DOCUMENT - 2025-366T HELIPORT RETROFIT IMPLEMENTATION AT 13653 MCLAUGHLIN ROAD, CHELTENHAM, PEEL REGIONAL POLICE FACILITY ADDENDUM 3

Number of Pages: 6 + Drawing (1 page)

HELIPORT RETROFIT

GENERAL NOTES AND DETAILS

A SECTION - OUTDOOR GENERATOR CONCRETE PAD SCALE: 1:25

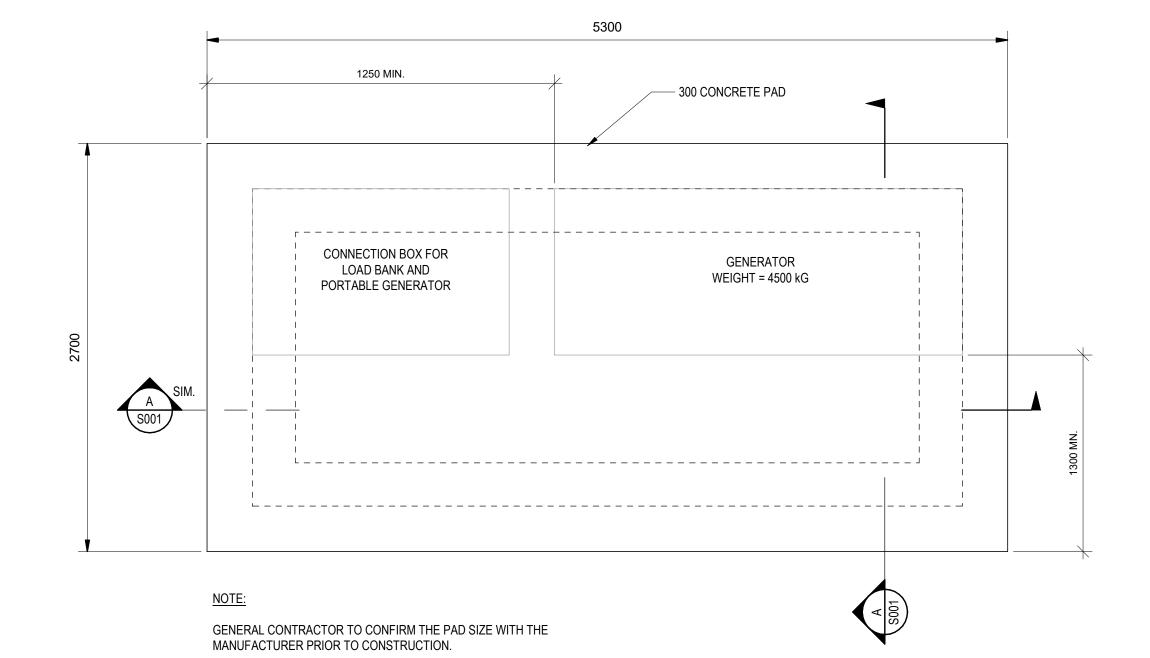
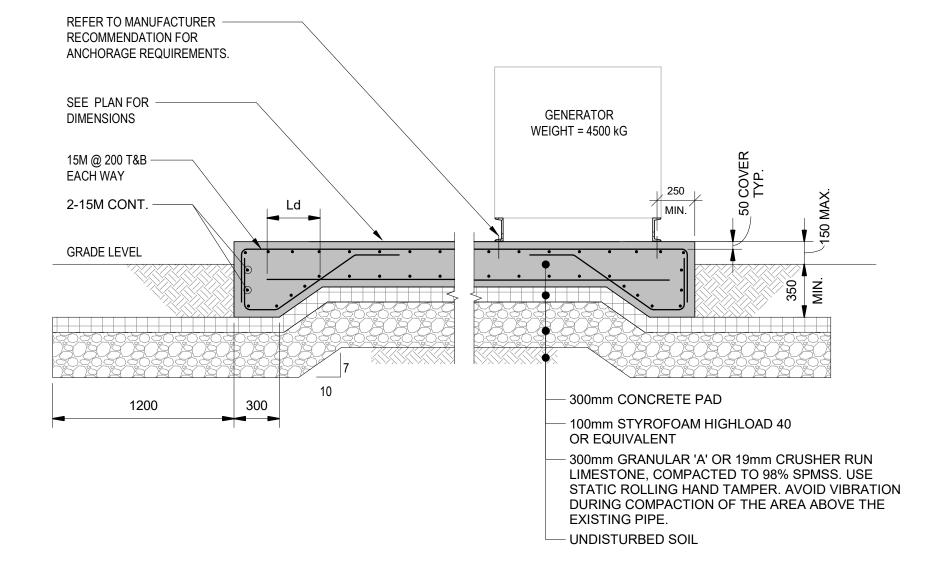
Drawing S-001 General Notes and Details (New Drawing Issued)

New drawing issued detailing concrete housekeeping pad for backup generator

Refer to new typical underground concrete duct detail on drawing ES101 which shall be considered applicable to all buried conduit required for the scope detailed on that sheet. Refer to new structural drawing S-001 for details pertaining to the generator concrete housekeeping pad. Exact concrete pad details to be coordinated with final generator shop drawing.
